TOWN OF CORTLANDT PLANNING BOARD

**MEETING AGENDA..... PLANNING BOARD
TOWN OF CORTLANDT
6:30 TUESDAY EVENING*
MARCH 3, 2026**

PB 2025-7 a. Public Hearing: Application of the Yeshiva Ohr Hameir for Site Plan approval, an amended Special Permit for a University, College or Seminary and a Wetland Permit for a proposed 51,730 sq. ft. dormitory building, the repurposing of other buildings on site, and site improvements including stormwater, landscaping and building façade renovations located at the existing Yeshiva Ohr Hameir campus at 141 Furnace Woods Rd. Drawings latest revised February 18, 2026. (see prior PB 7-09)

LaBella has performed a review of the plans prepared by Ciarcia Engineering, P.C. in support of the “Amended Site Plan associated with the construction of the three-story dormitory building, extension of sanctuary building, conversion of existing classrooms to staff housing, storage building, cafeteria and kitchen renovations, chalet renovation, façade improvements, and associated utility improvements. submitted on February 9, 2026.

**INFILTRATION TRENCH
N.T.S.**

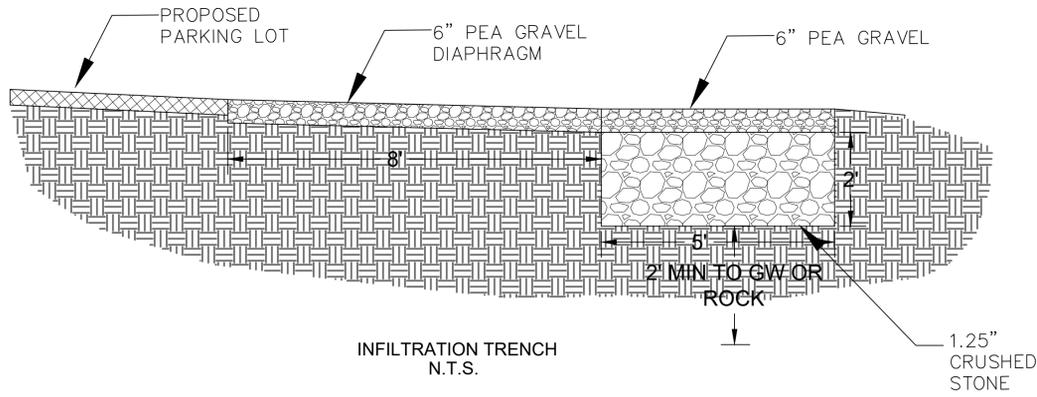
56. Sheet 14 of 15 - Provide filter fabric around the stone infiltration trench
57. Sheet 14 of 15 - The infiltration trench detail appears to depict a perforated underdrain. The Applicant should clarify the intent of this and include it in the model if necessary.

58. Sheet 14 of 15 - The infiltration trench detail should be revised to include the grass filter strip and any other pretreatment practices proposed, as well as detailing and specifying the engineering soils used to construct the infiltration trench. Means of preventing seeps or breakouts shall also be provided. Refer to section 6.3.1 and Table 6.12 of the NYS DEC SWDM.

59. Sheet 14 of 15 - Revised the stone material to indicate a no 2 clean washed stone in the infiltration trench.
60. Sheet 14 of 15 - As per the detail on page 6-36 of the NYS DEC SWDM, provide a 4" pea gravel top surface and 6" perforated observation well in the infiltration trench design. An alternative to a pea gravel top layer is topsoil and lawn.

61. Sheet 14 of 15 – Indicate a 24-inch minimum separation to groundwater and bedrock is required from the bottom of stone for the infiltration trench detail.
62. Sheet 14 of 15 – Provide bedding and backfill requirements for the hydrodynamic separator. It also appears notes and a key are missing from the details.
63. Sheet 15 of 15 – Sections of the proposed walking trail traverse through the on-site NYSDEC wetland. Due to the potential for standing water and saturated soil within wetland areas, the location of the trail should be reevaluated.
64. Sheet 15 of 15 – What will be the surface of the trail and how will it be constructed? Since portion of trails considered within the wetland and on-site buffer, does NYSDEC permit application consider such improvements?

Response 57: The infiltration trench detail has been revised to eliminate the underdrain and include a pea gravel diaphragm upstream of the practice. *The revised detail is provided on the Misc Details sheet (Sheet 15 of 16)*
